Attention:	Brian Richardson	Date:	12/8/2014
Company:	C.C.S. Constructors	Job Name:	Stowe BRF 0235(11)
Address:	138 Munson Ave	Job Number:	#15163
City, St, Zip:	Morrisville, VT 05661	Regarding:	Abutment, Wing Wall, and Retaining Wall Submittal #1
Ph: / Fax:	802-888-7701

Stowe BRF 0235(II)

Vermont Agency of Transportation
RECEIVED
Abutment_WingWall_RetainingWall Submittal 1 120814_Resubmit 12.22.14.pdf

WW3: Plan View

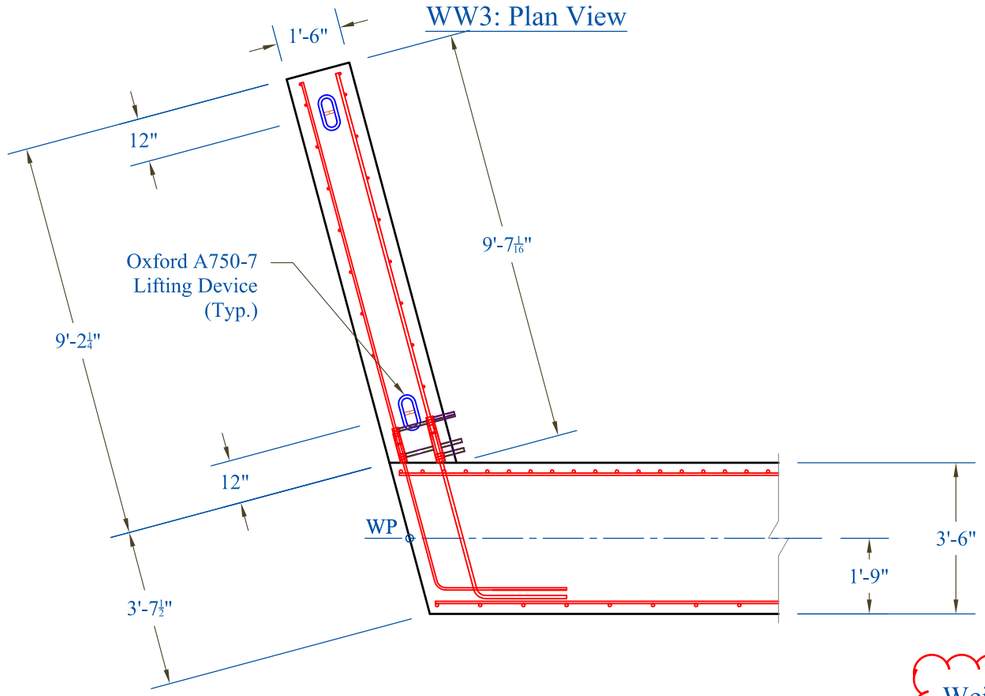
Verify this weight, appears low. Should be similar to Wingwall #1 since same dimensions except for height elevations.

WW3: Elevation View

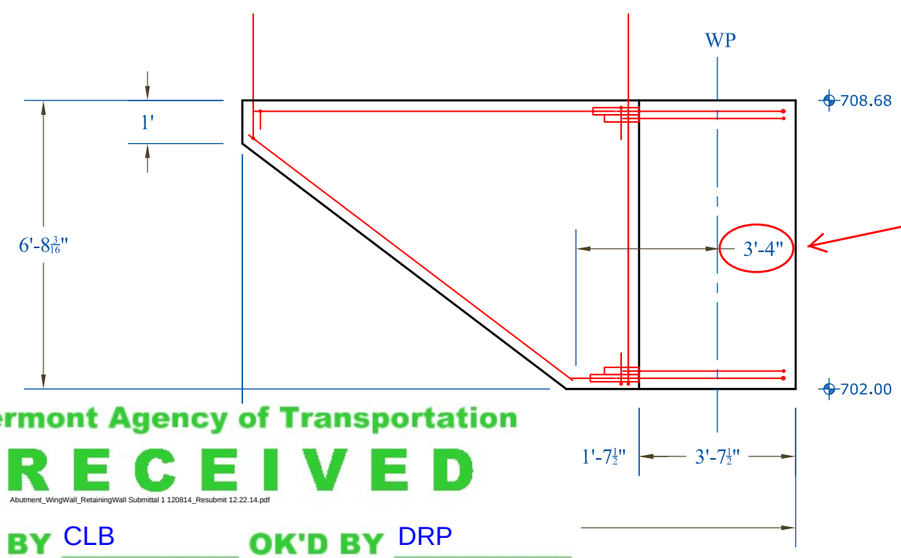
Should be 3'-6". Dimension line does not appear to extend to the corner.

Abutment Face: A-A

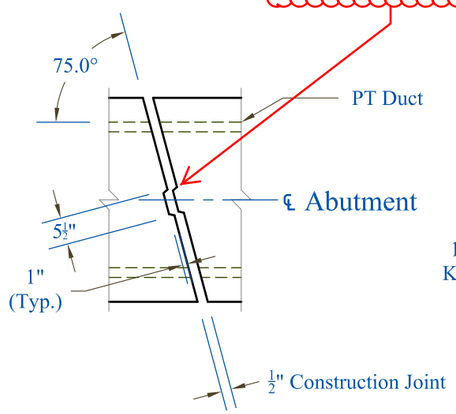
Please provide more dimensions on the key

Abutment 1 & 2: Typical Section

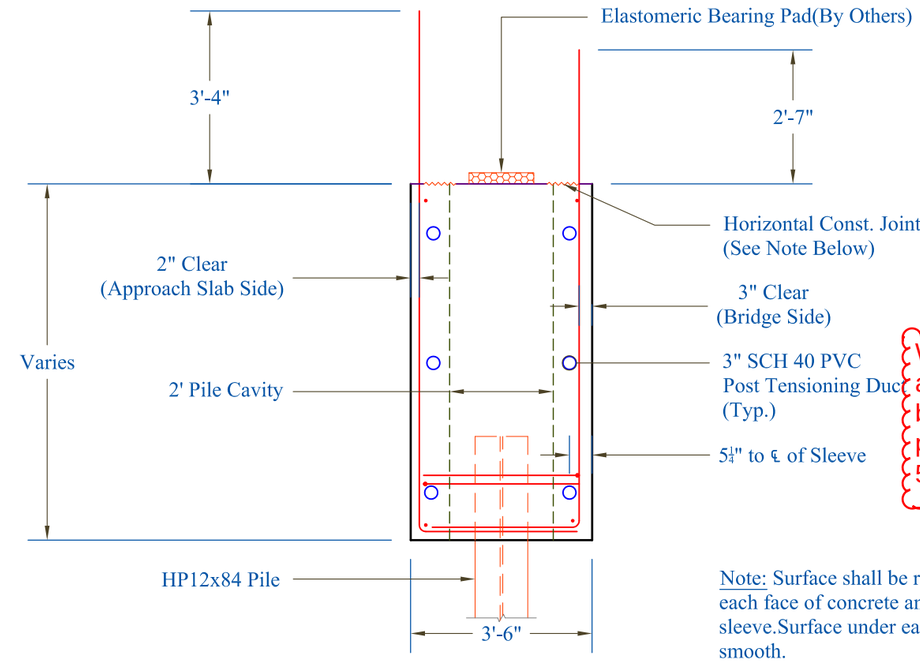
What is the amplitude? Should be 1/4"-1/2" deep per VTrans std 501.00.

Wingwall Grout Sleeve Detail

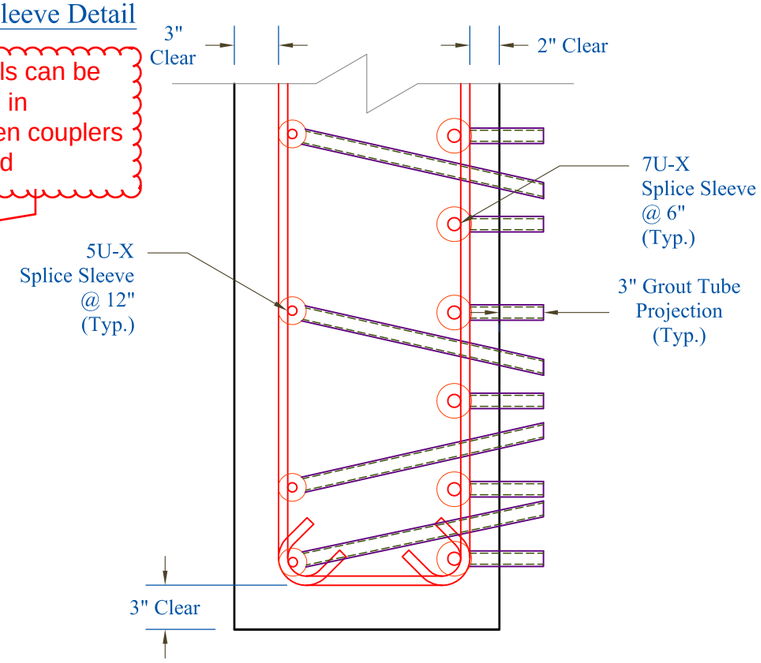
verticals can be moved in between couplers to avoid

Wingwall 1 - 4: Typical Section

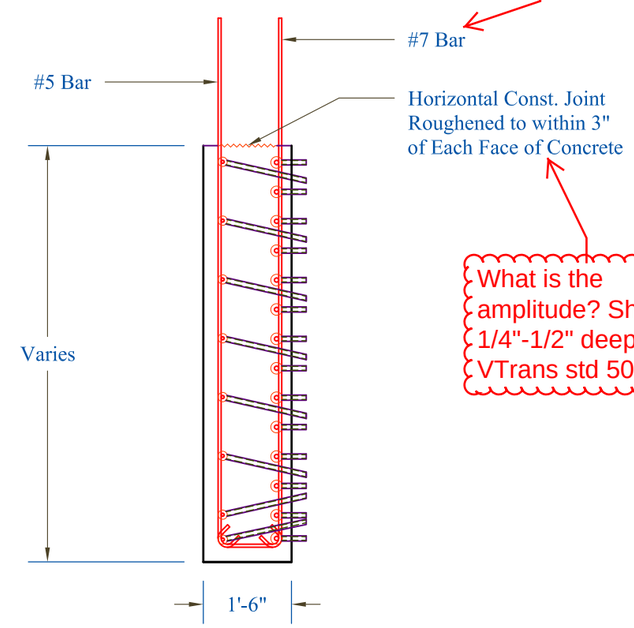
What is the amplitude? Should be 1/4"-1/2" deep per VTrans std 501.00.

End Bar Detail: Abutment 1

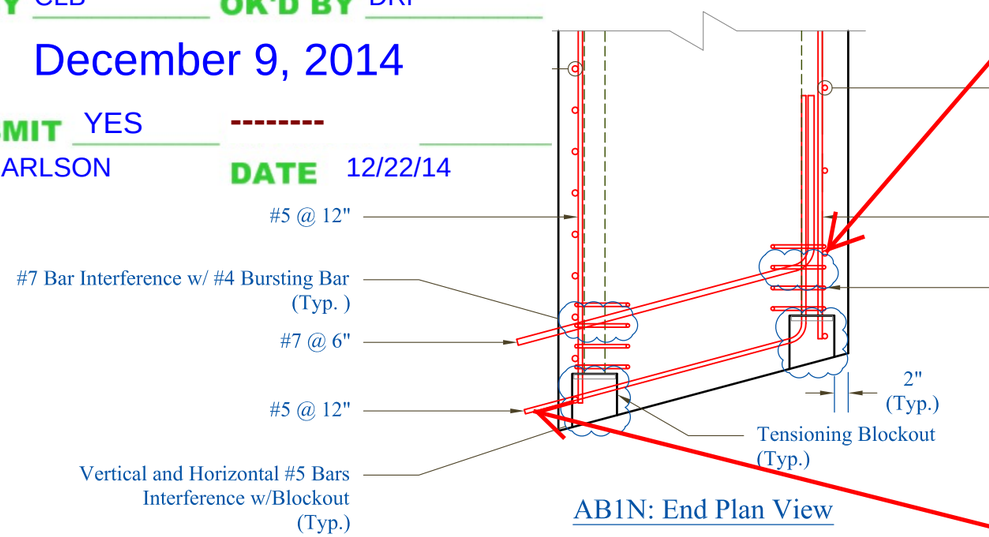
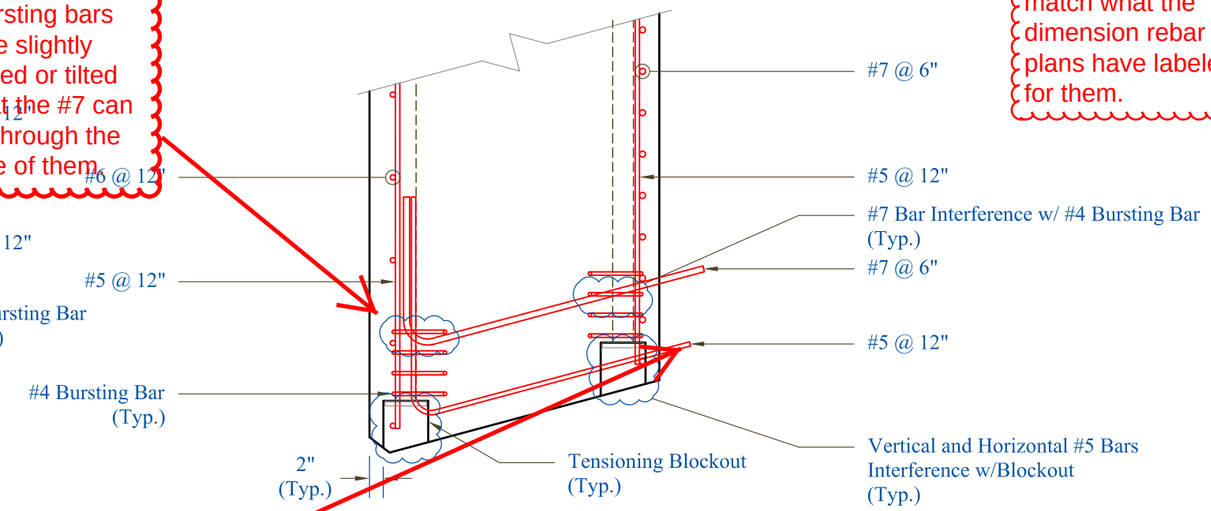
it appears that the #4 bursting bars can be slightly adjusted or tilted so that the #7 can pass through the middle of them.

Rebar ID should reference and match what the dimension rebar plans have labeled for them.

projection distance? typical sheet 11

AB1N: End View

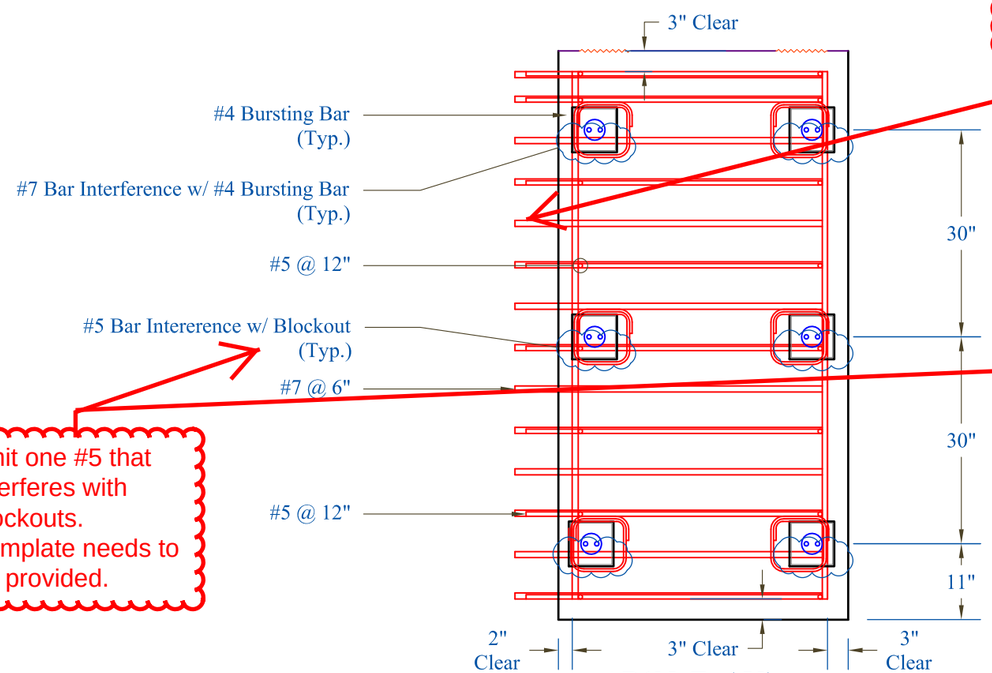
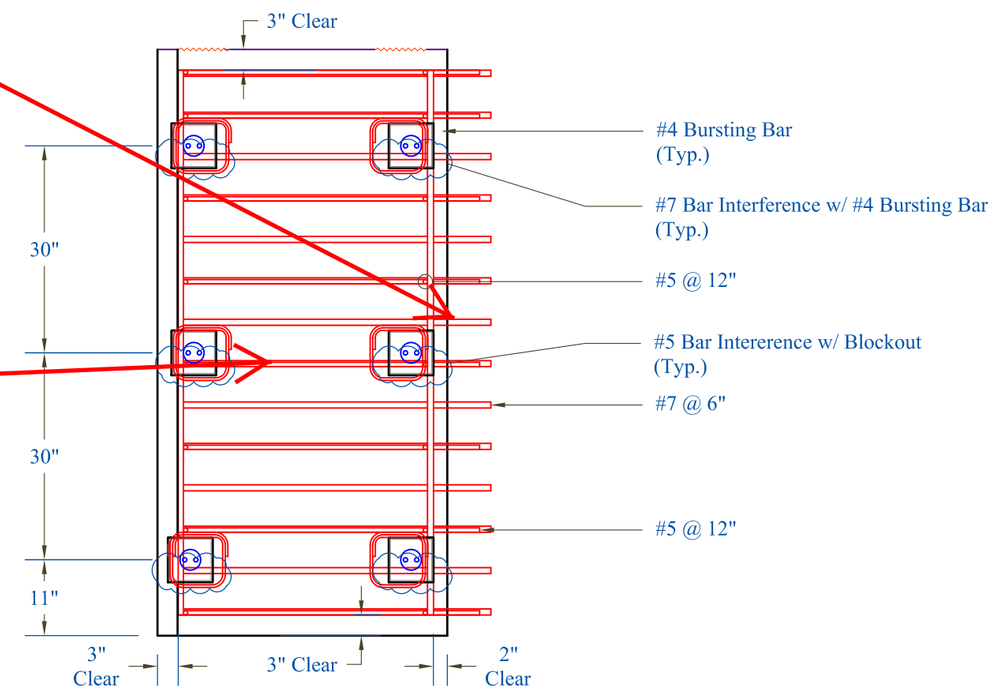
omit one #5 that interferes with blockouts. Template needs to be provided.

End Bar Detail: Abutment 2

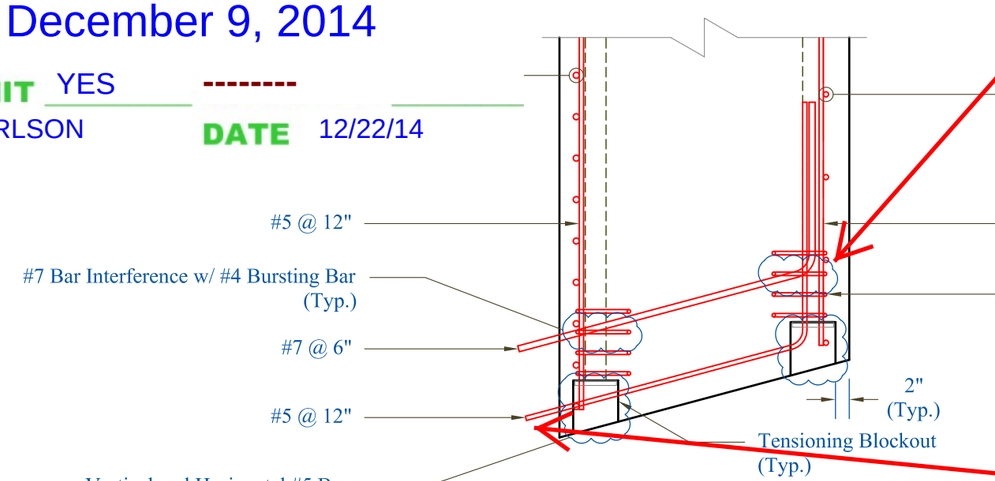
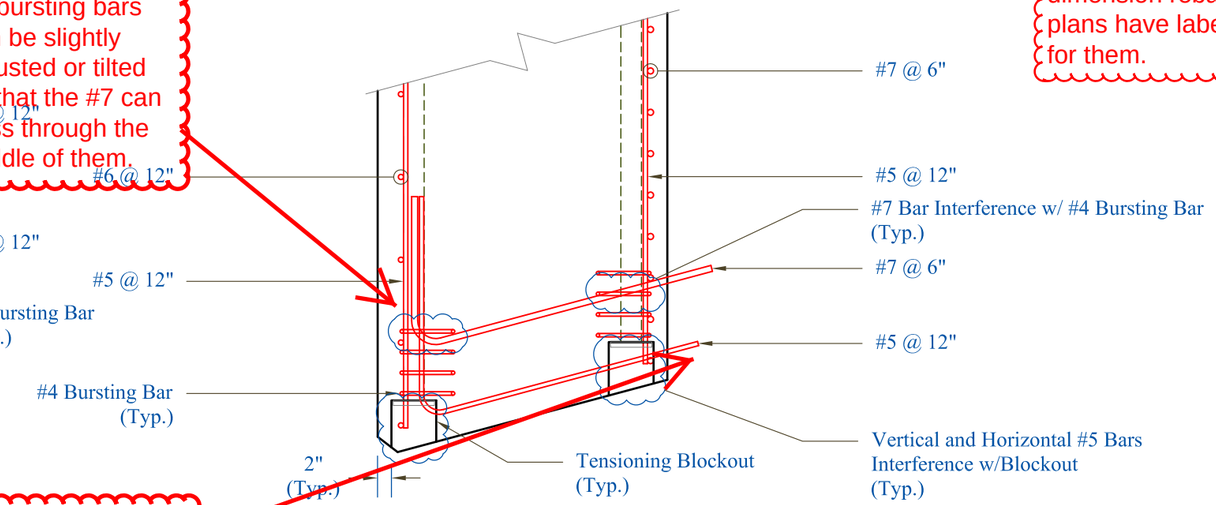
Rebar ID should reference and match what the dimension rebar plans have labeled for them.

it appears that the #4 bursting bars can be slightly adjusted or tilted so that the #7 can pass through the middle of them.

projection distance?

AB2S: End View

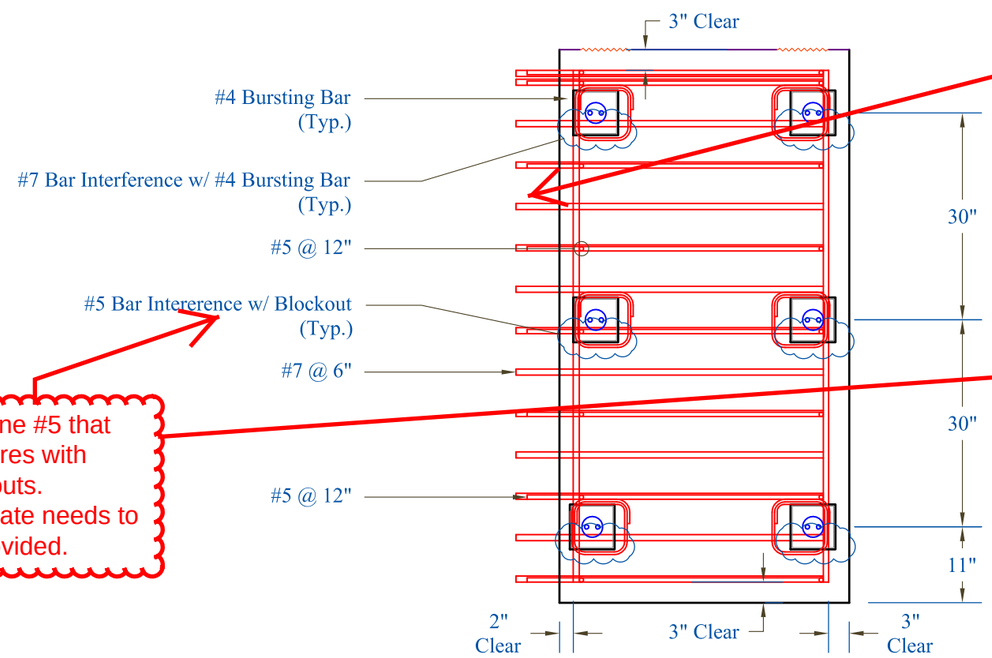
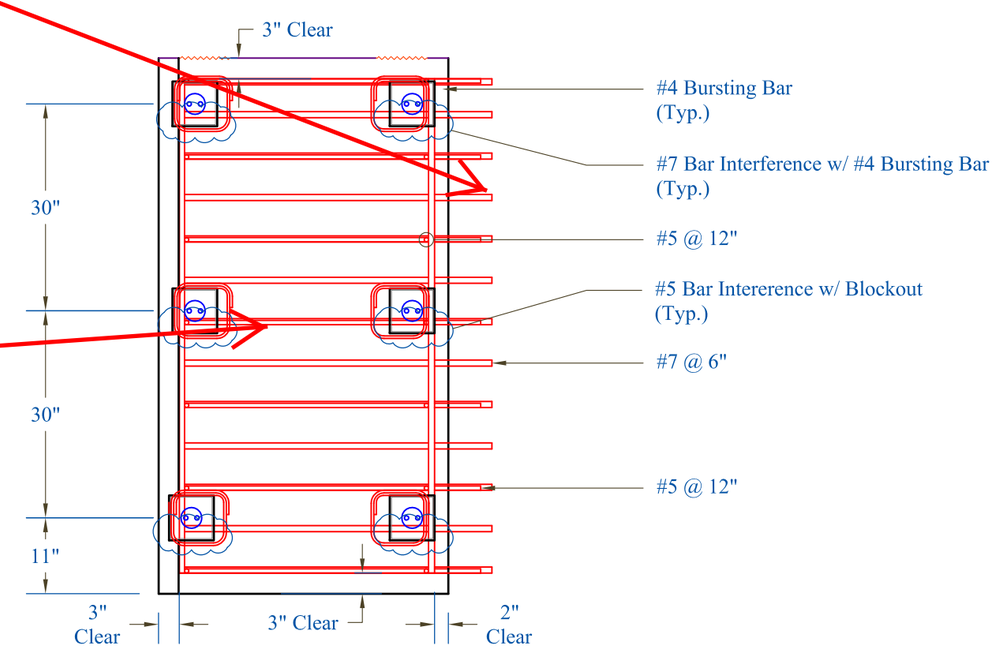
omit one #5 that interferes with blockouts. Template needs to be provided.

ABUTMENT #1 PLAN
VERTICALS NOT SHOW FOR CLARITY

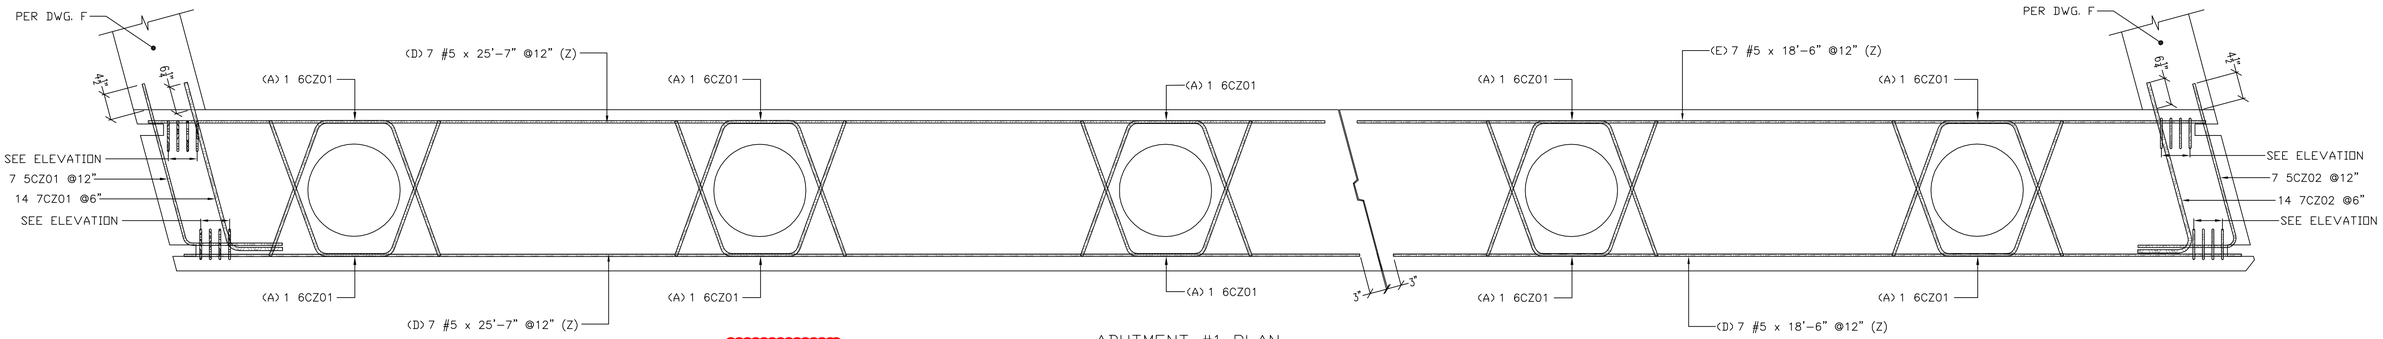
this bars need to be spaced to avoid girders.

STRUCTURE: VTAOT STOWE BRF 0235(11)
LOCATION:
ARCHITECT:
ENGINEER:
CUSTOMER: SD IRELAND CONCRETE CONST. CORP.
DRAWN BY: ED
DATE: 12/5/14
DFI #: 9117
DRAWING COVERS: WINGWALLS 1 & 2 DUAL COATED REINFORCING
DRAWING #: F

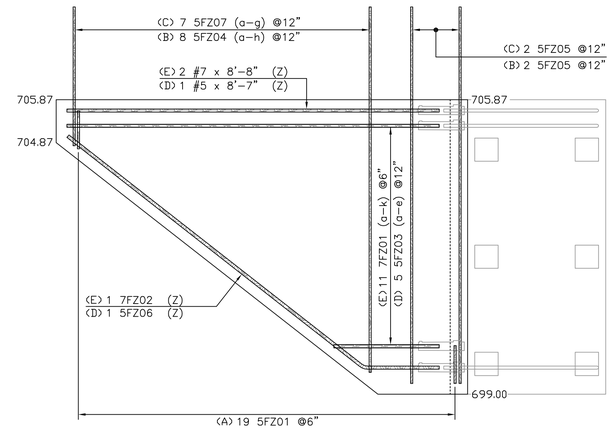
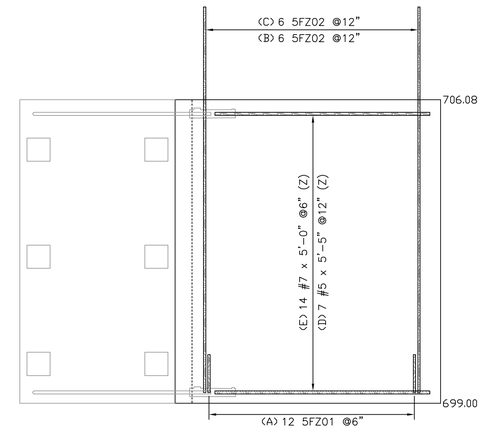
Please verify and resubmit the reinforcing steel schedule for all the Wingwalls.
-There are a lot of differences in the schedule and labeling on sheet J for Wingwalls #3 and #4 and a lot of errors, so please also verify Wingwalls #1 and #2
-Besides the labels, Wingwall #2 and Wingwall #3 should be approximately the same.

STRUCTURE: VTAOT STOWE BRF 0235(11)
LOCATION:
ARCHITECT:
ENGINEER:
CUSTOMER: SD IRELAND CONCRETE CONST. CORP.
DRAWN BY: ED
DATE: 12/5/14
DFT #: 9117
DRAWING COVERS: WINGWALLS 3 & 4 DUAL COATED REINFORCING
DRAWING #: J

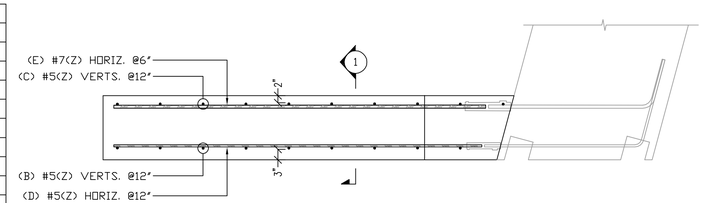
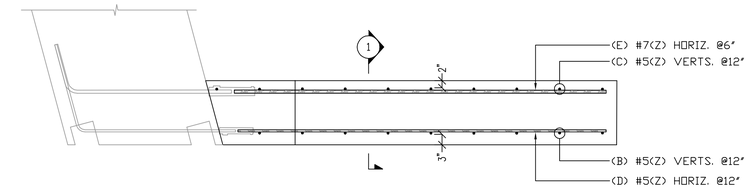
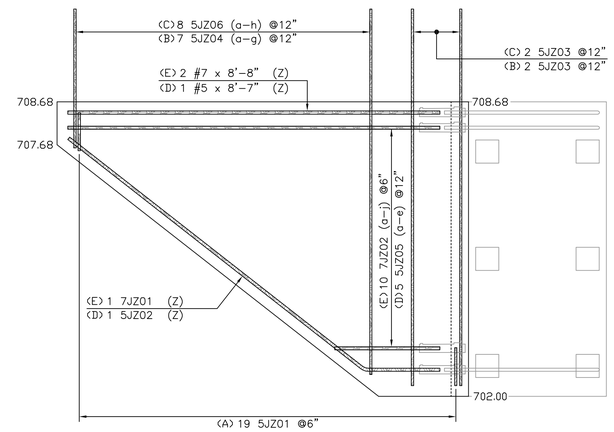
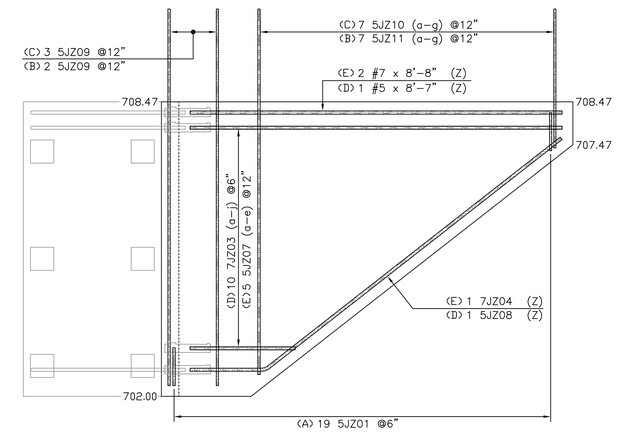
Please verify and resubmit the reinforcing steel schedule for all the wingwalls.
-5JZ03 should have quantity of 4
-5JZ04 should have a-g
-5JZ105 in schedule is (a-g) but labeled on drawing (a-e)
-5JZ06 should be #21
-5JZ06 in schedule is (a-e) but labeled on drawing (a-h)
-Missing 5JZ07 (a-e)
-Missing 5JZ08
-Missing 5JZ09
-5JZ10 in schedule is (a-h) but labeled on drawing (a-g)
-5JZ11 in schedule is (a-e) but labeled on drawing (a-g)
-5JZ10 and 5JZ11 should be the same bar type (#21)
-7JZ02 bars are straight but 5JZ05 are #21? The equivalent bars for wingwall #2 are straight
-What are bars 5JZ12, 5JZ13, 5JZ14, 5JZ15 (a-g), and 5JZ16 (a-e)
-Besides the labels, wingwall #2 and wingwall #3 should be approximately the same.
